REFERENCE INFORMATION & FILE NO. OF SURVEYS				DESIGN & ENGINEERING CITY & COUNTY OF SAN FRANCISCO SAN FRANCISCO PUBLIC WORKS 30 VAN NESS AVENUE, 8TH FLOOR SAN FRANCISCO, CA 94102 - 5029	DESIGNED: DATE: 11/14/16 J.K./A.S.			SCALE:	2ND STREET STREETSCAPE IMPROVEMENTS PROJECT	CONTRACT NO. 1064J(R)
				74.108 55.291					DRAWN: DATE: 11/14/16 A.KIRSCH			SHEET OF SHEETS		2ND STREET SEWER REPLACEMENT STATION 22+00 TO 27+50 PLAN AND PROFILE
TABLE OF REVISIONS														FILE NO. 106.247
														REV. NO. 0

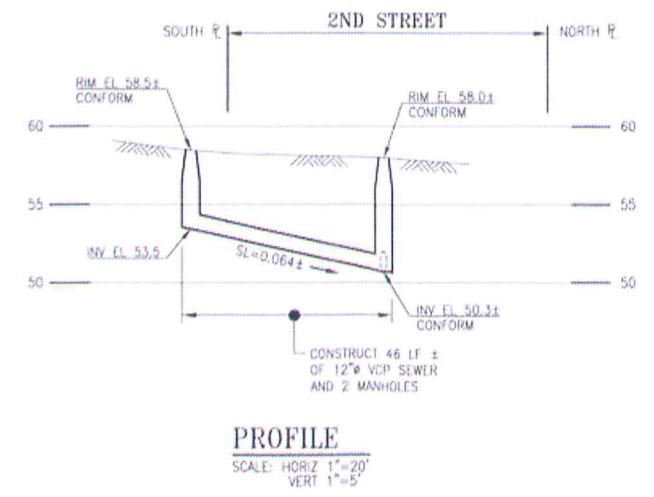
9 Potholes.
 4cy x 9
 = 36 cy.
